ADDENDUM # 001

Holy Family Catholic School
649 Murray St.
Wallaceburg, Ontario

FDK Classroom and Washroom Renovations

Project No. 616-CP1834

DRAWING TITLE:
PART DEMOLITION PLAN

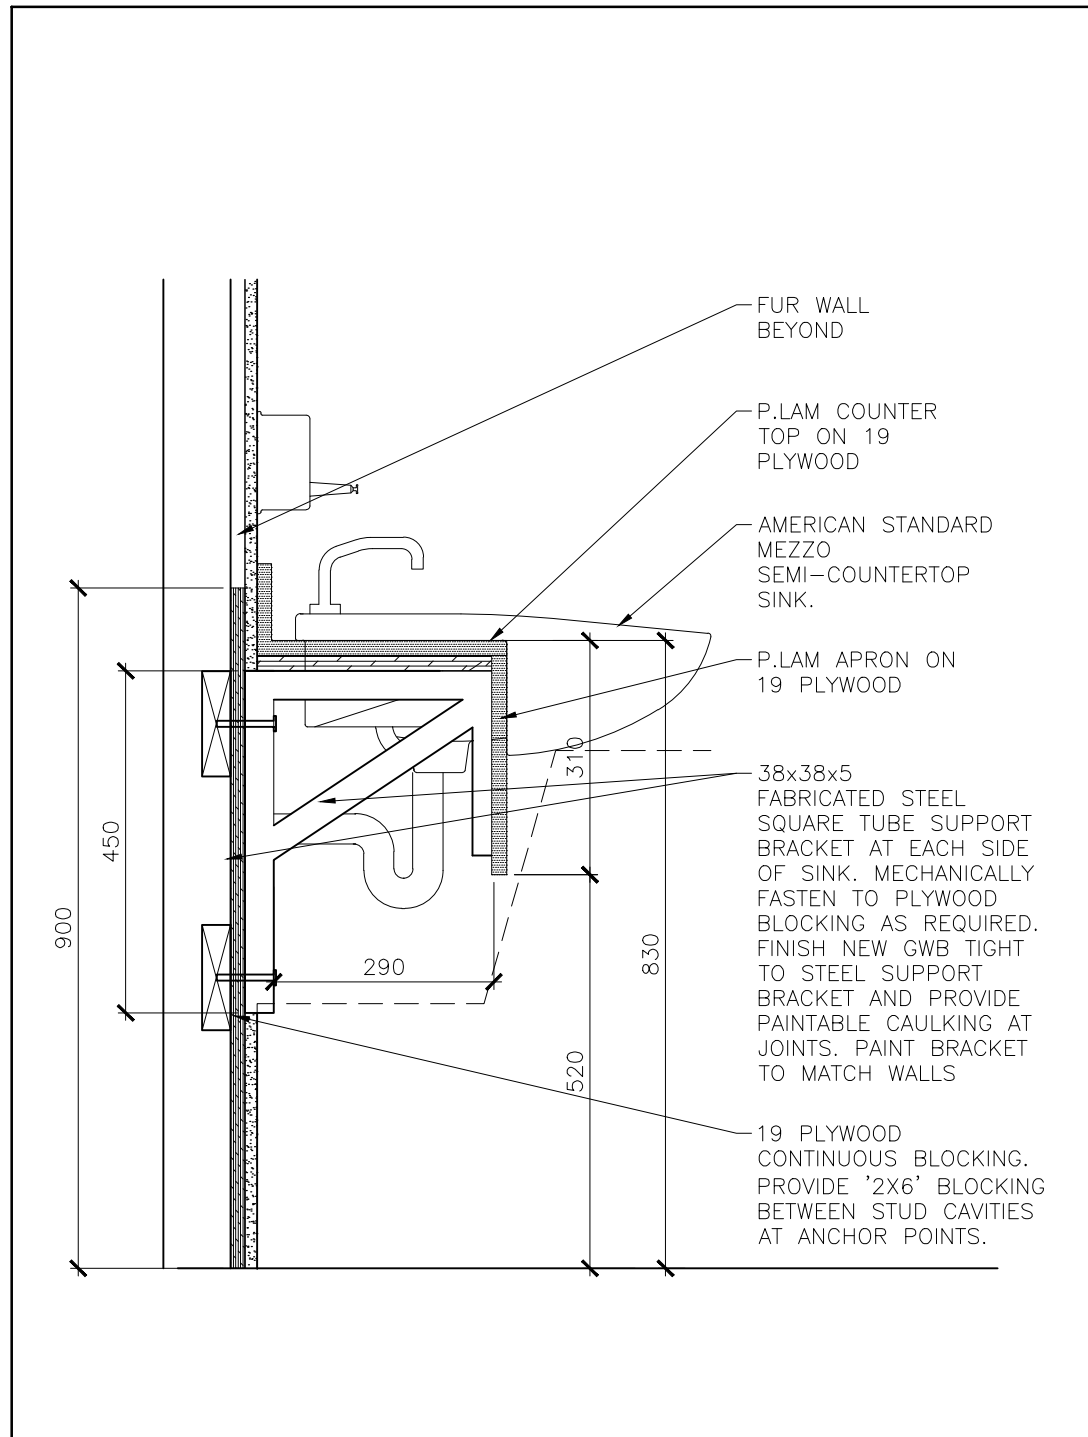
REMOVE EXISTING
TERAZZO FLOOR
THROUGHOUT EXISTING
WR 122.

EXISTING WALL INDICATED
ON PREVIOUS PLAN
DOES NOT EXIST.
PROVIDE HOARDING

EXISTING LOAD
BEARING WALL.
REFER TO
STRUCTURAL

WALL TO BE
FLOOR SLAB.
STRUCTURAL

ELECTRICAL PANEL
TO BE RLOCATED.
REFER TO
ELECTRICAL

EXISTING FLOOR SLAB TO
BE DEMOLISHED.
REFER TO MECHANICAL,
ELECTRICAL AND
STRUCTUAL DRAWINGS
